# PIC32MZ EF FAMILY

## PIC32MZ Embedded Connectivity with Floating Point Unit (EF) Family Silicon Errata and Data Sheet Clarification

The PIC32MZ Embedded Connectivity with Floating Point Unit (EF) family of devices that you have received conform functionally to the current Device Data Sheet (DS60001320G), except for the anomalies described in this document.

**FIGURE 1: Posc CRYSTAL CIRCUIT**

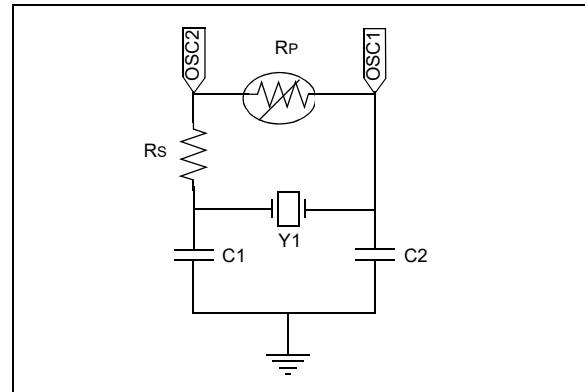
**Revision A1 Silicon:** A crystal oscillator cannot be used as an input to the Primary Oscillator (Posc) pins OSC1 and OSC2.

**Revision A3 and B2 Silicon:** The Posc has been tested in a normal power-up sequence and supports specific crystal operation.

The Primary Oscillator (Posc) has been characterized to operate at 8 MHz, 12 MHz, and 24 MHz when the circuit in [Figure 1](#) is implemented, and the operating conditions listed in [Table 3](#) are met.

Crystal Frequency (see Note 1)	Series Resistor (Rs)	Posc Gain Setting POSCGAIN<1:0> (DEVCFG0<20:19>)	Posc Boost Setting POSCBOOST (DEVCFG0<21>)
8 MHz	2 kΩ	'0b00 (GAIN_0)	'0b1 (ON)
12 MHz	1 kΩ	'0b00 (GAIN_0)	'0b1 (ON)
24 MHz	0 kΩ	'0b00 (GAIN_0)	'0b1 (ON)

- Note 1:** Using any other crystal frequency will require special component selection and characterization.  
**Note 2:** A parallel resistor (Rp) should not be used to increase the gain of the POSC.

### 64-PIN QFN<sup>(4)</sup> AND TQFP (TOP VIEW)

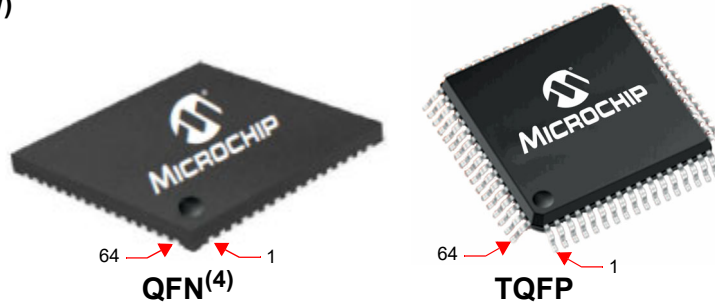
In Table 2. “Pin Names for 64-pin QFN and TQFP Devices” of the current data sheet, the AECRS<sub>DV</sub> signal was erroneously omitted from the pin number 44 and added to the pin number 62. The correct assignment is shown in bold type in the following table.
